Work Order ID 92974

Item Name: Thrusert

APICAL INDUSTRIES, INC.	ENGINEERING CHANGE NOTIC. NO. 03294				SHEET 1 OF 1	
	DWG NO. 647.9100	REV: N/C	PREPARED BY A. QUAN	DATE: 12/07/11	EFFECT ON DWG <input type="checkbox"/> INC. <input checked="" type="checkbox"/> UNINC.	
	DWG TITLE: THRUSERTS					
APPROVED BY: ENGR <i>[Signature]</i>		MFG <i>[Signature]</i>	QC <i>[Signature]</i>	EFF: CURRENT ORDER		
TRANSACTION CODES (TC): A-ADD C-CREATE R-REVISE D-DELETE		REASON: REVISED MATERIAL DUE TO AVAILABILITY ISSUES

647.911X

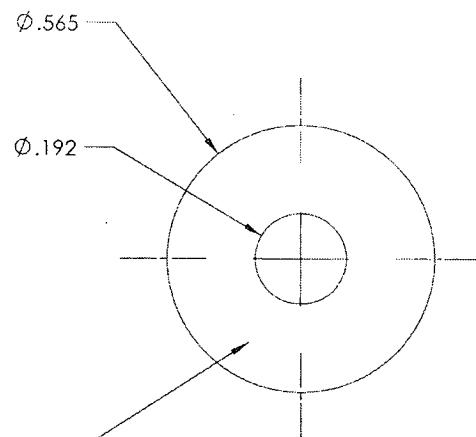
1. MATERIAL: 303 SS IAW AMS 5643, 1/4H.
2. FINISH: NONE.
3. DEBURR AND BREAK ALL SHARP EDGES.
4. IDENTIFY IAW MPP-120. LASER ETCH P/N AND REVISION 12 PT. CENTURY GOTHIC.

**SHEET 1, NOTES IS:**

1. MATERIAL: 303 SS IAW AMS 5640.
2. FINISH: NONE
